Erection of first floor rear extension at 16 Farmcroft Gravesend Kent DA11 7LT.

Please find enclosed an electronic application form and drawings for the above referenced address. This is a revision to the previously refused planning application **20200942**.

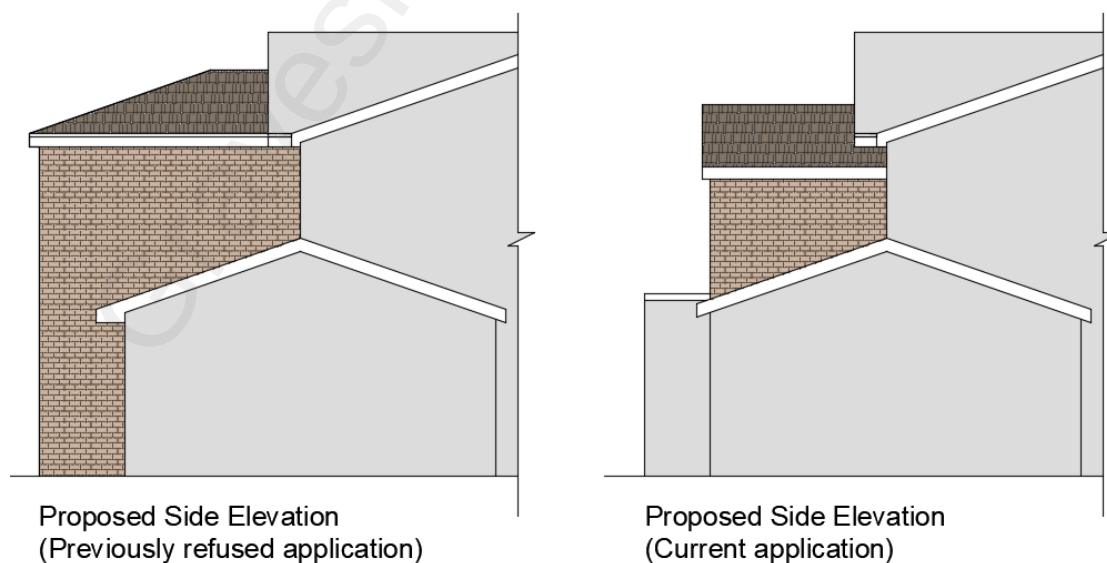
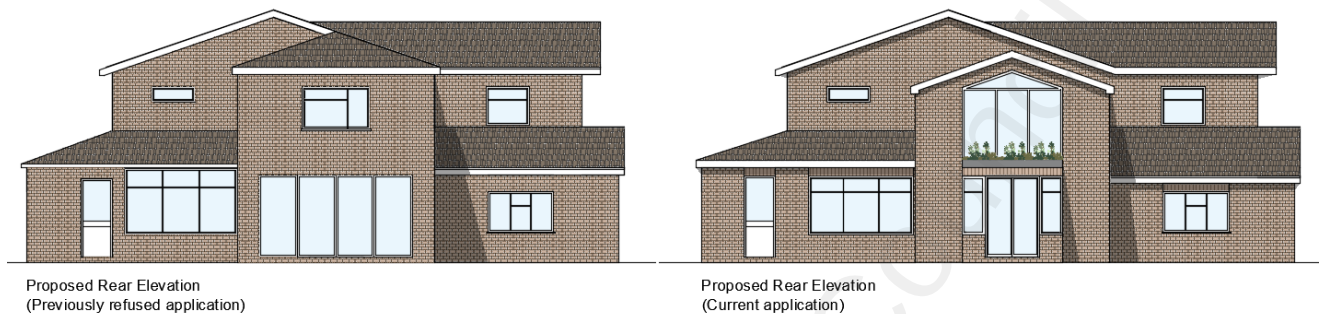
As shown in the below diagram the overall size of the extension has been reduced significantly to make it integrate well with the existing house, so that it does not appear bulky and incongruous addition to the house.

In the previous application, the proposed hipped roof design of the extension was considered awkward when read against the rear gable of the host dwelling. Therefore, in the current application the extension's roof has been changed to gable end with a lower eaves height to make it appear in keeping with the house and the street scene.
